ADDENDUM NO. 01

**REFERENCE NO. 2024-18-T
LEARNING COMMONS RENOVATIONS AT WOODMAN-CAINSVILLE SCHOOL,
AGNES G. HODGE PUBLIC SCHOOL AND SIMCOE COMPOSITE SCHOOL
FOR THE GRAND ERIE DISTRICT SCHOOL BOARD**

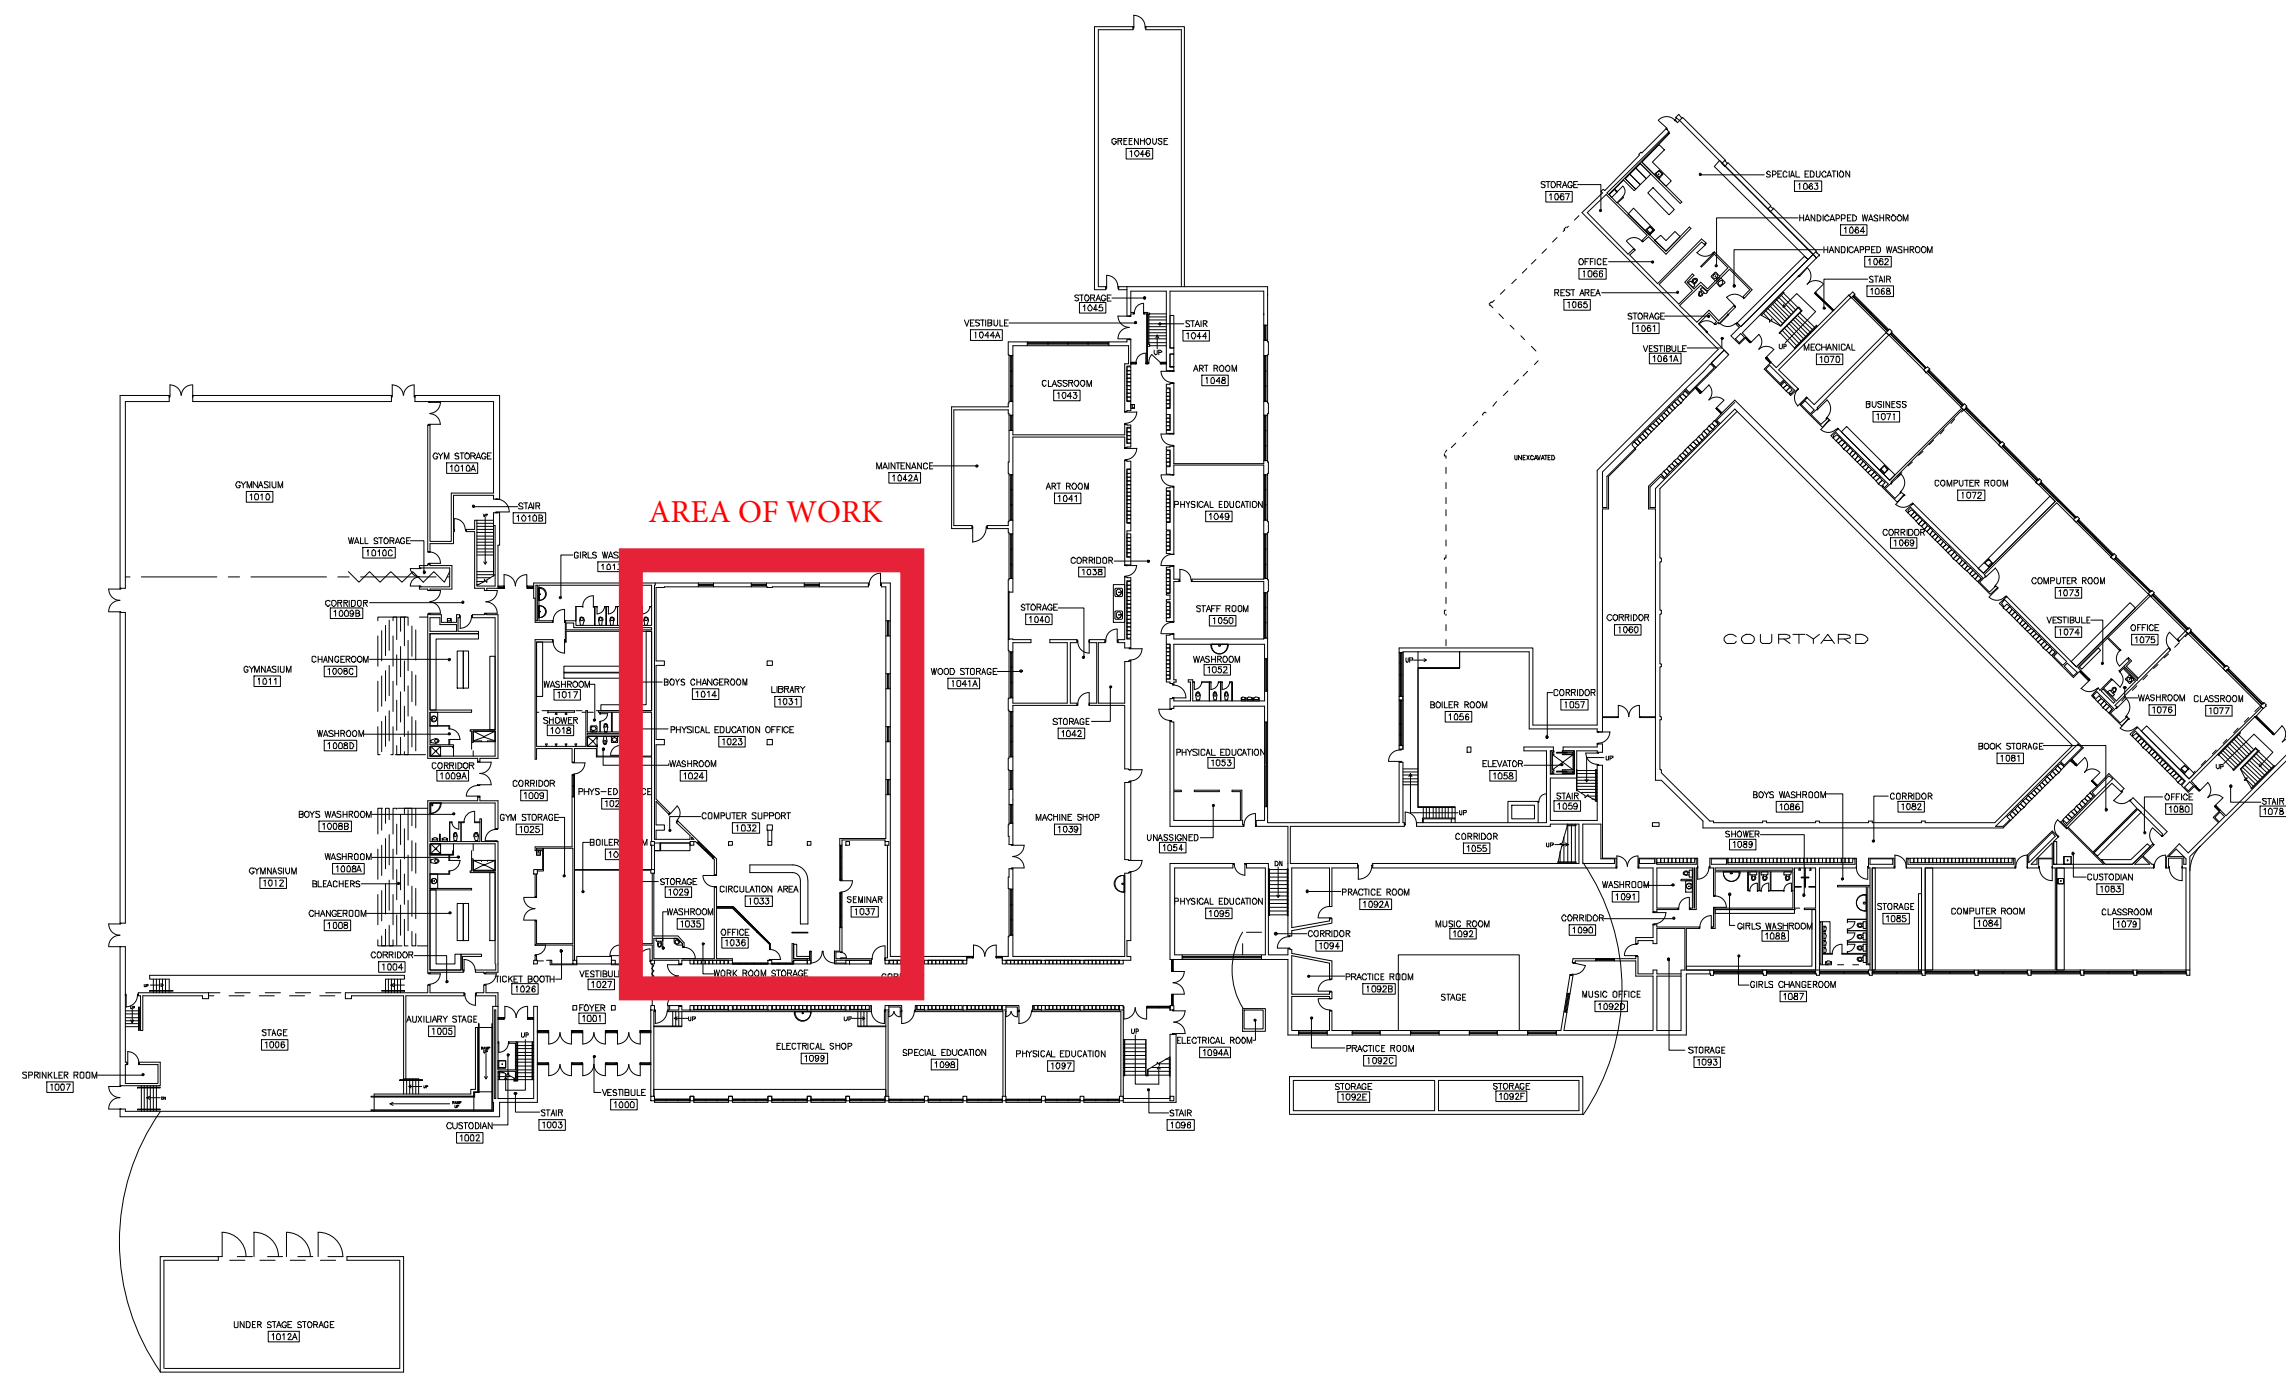
Q2 Appendix A, B and C were not included as part of the Original Documents that we have. Is it possible to get those resent to us?

A2 I assume he means the ones in the attached picture? Do you have these?

REV	DATE	DESCRIPTION	BY	CHKD
SIMCOE COMPOSITE SCHOOL				
TITLE: DIMENSIONS AND WALL TYPES				
SCALE: 1/8" = 1' 0"				
DWG No. KEY PLAN			REV	00

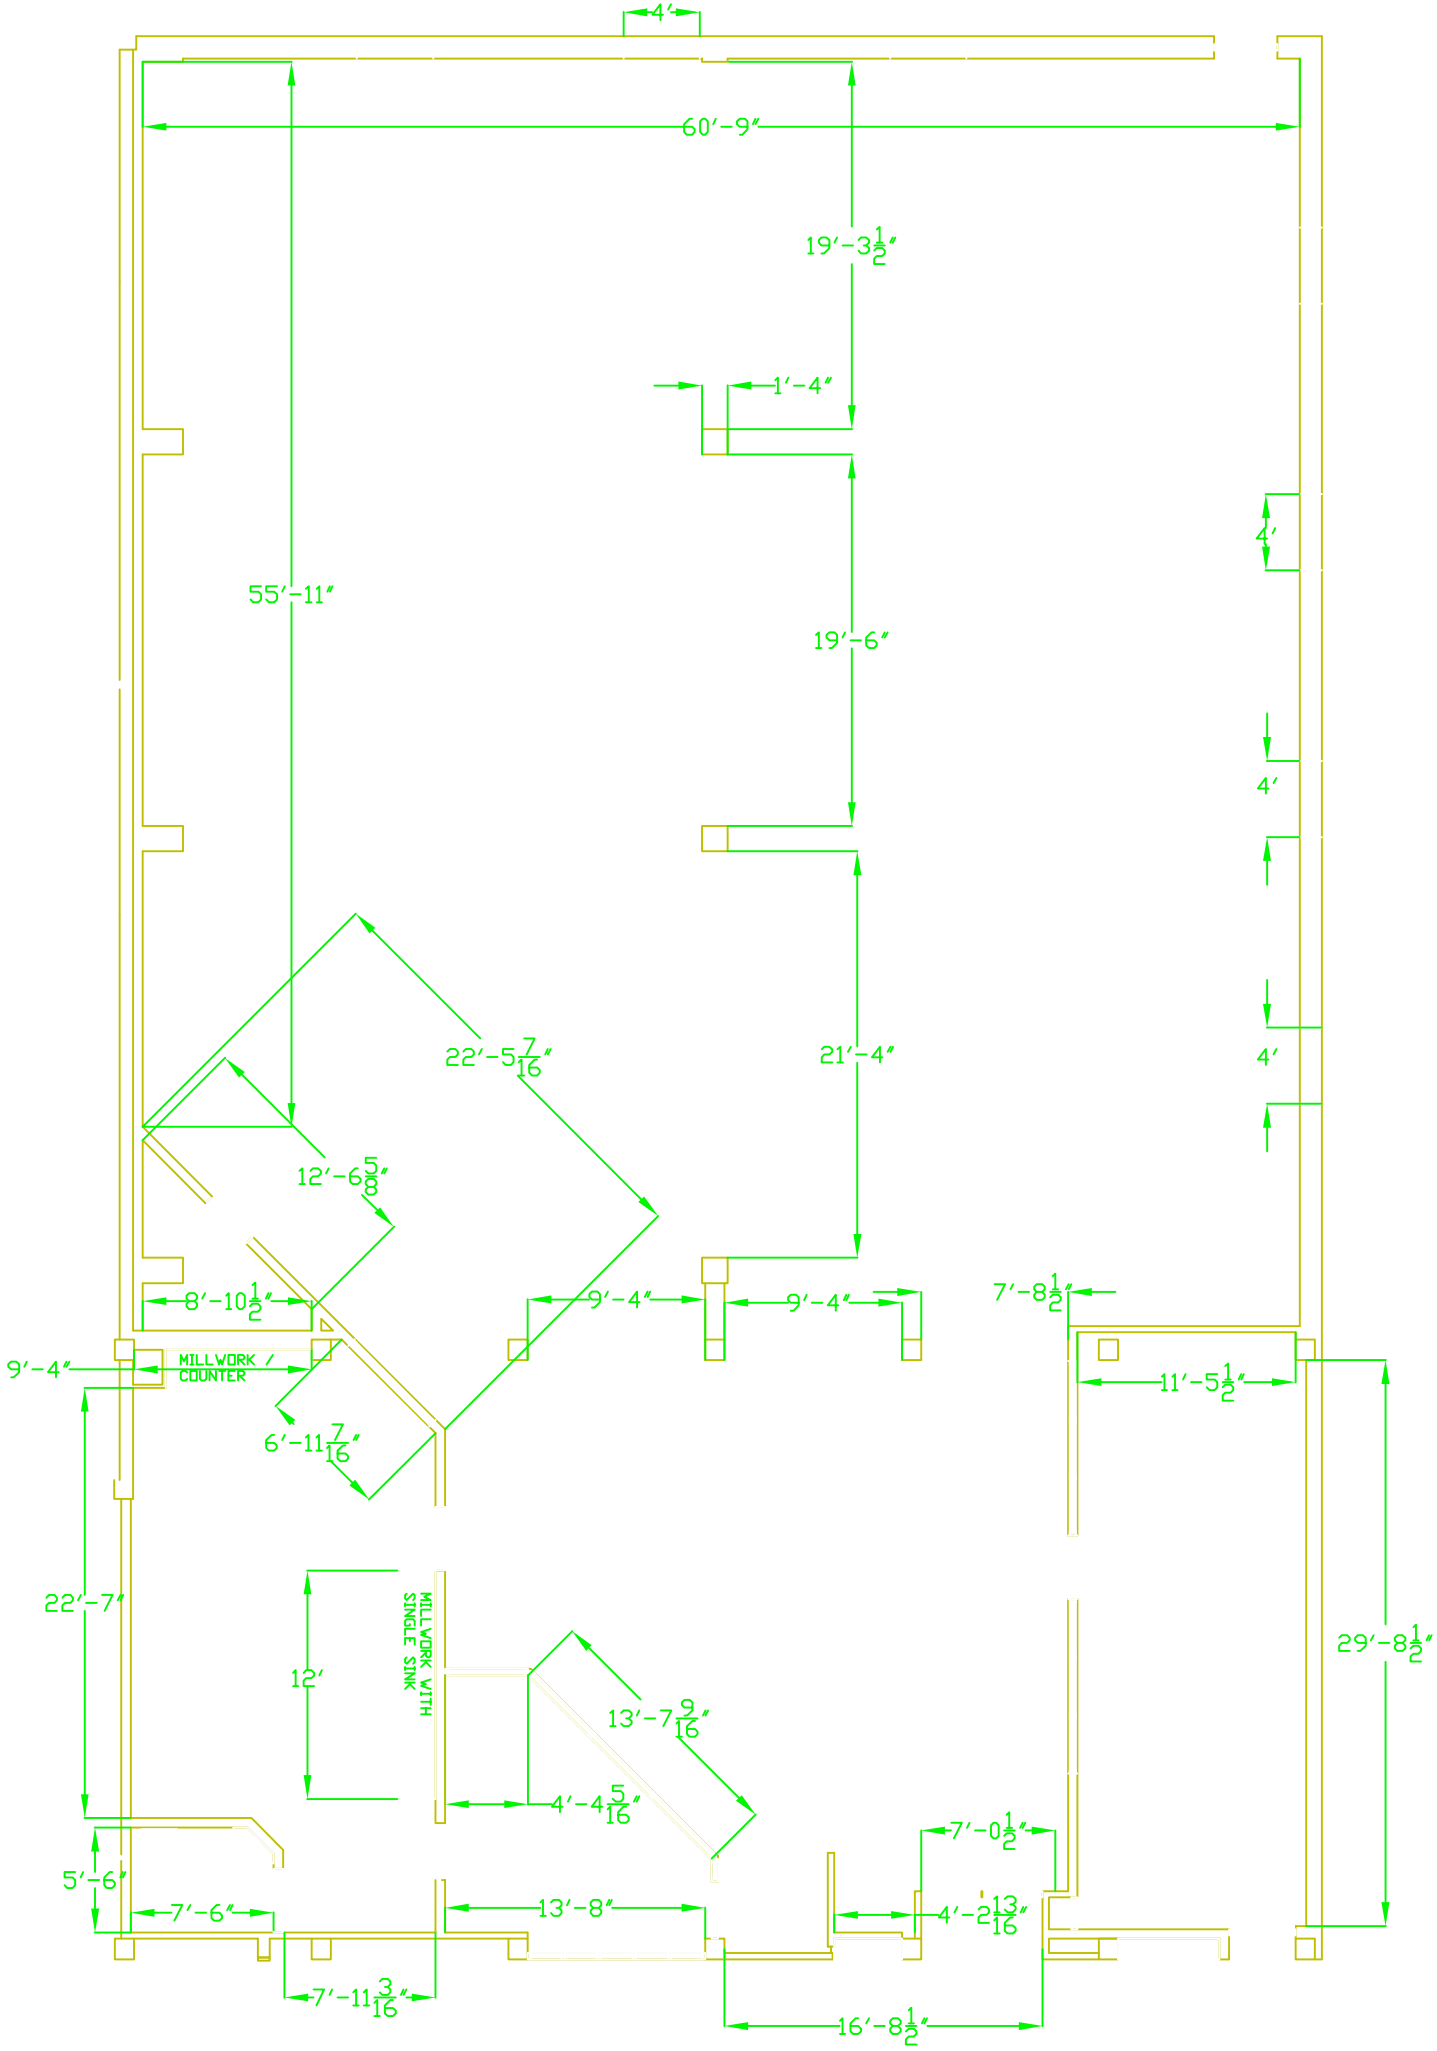
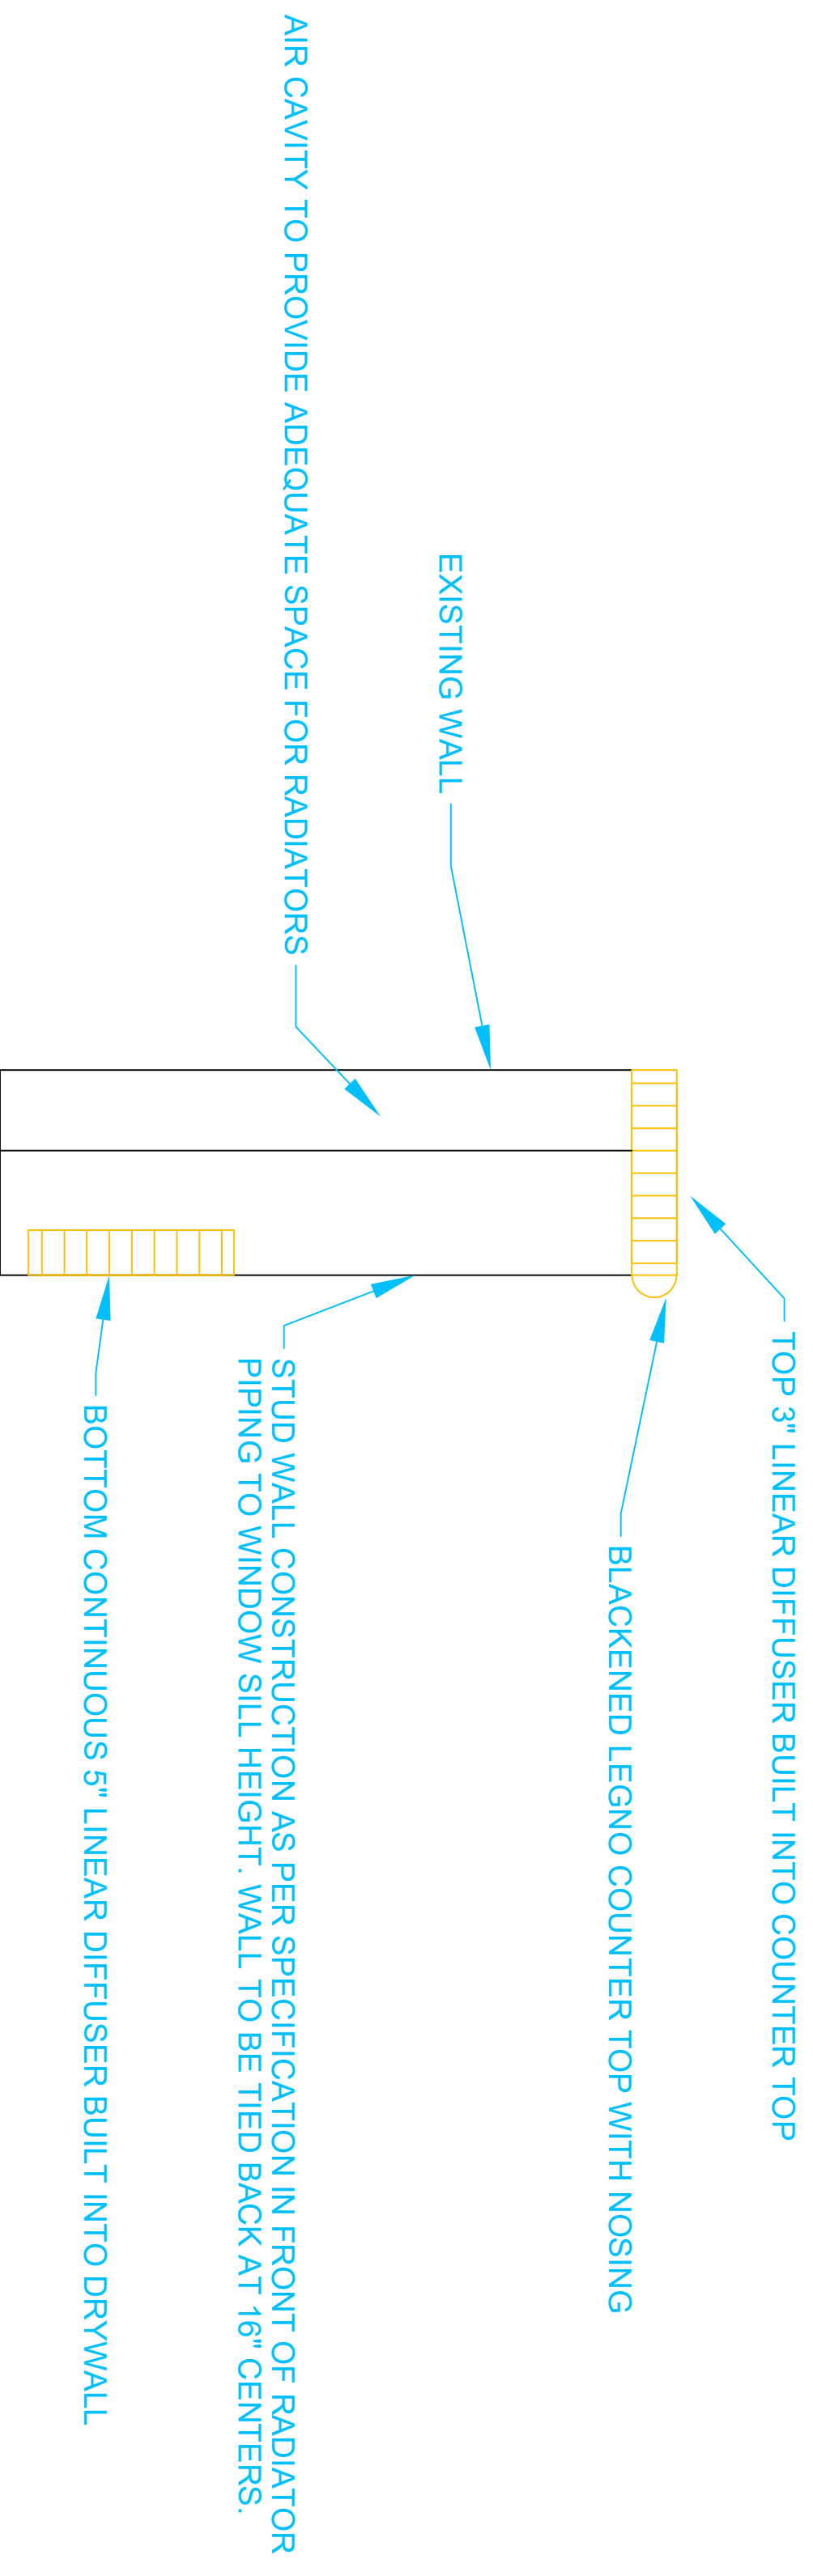
Q7 Is a dimensional drawing available for Simcoe, c/w wall schedule?

A7 See attached.
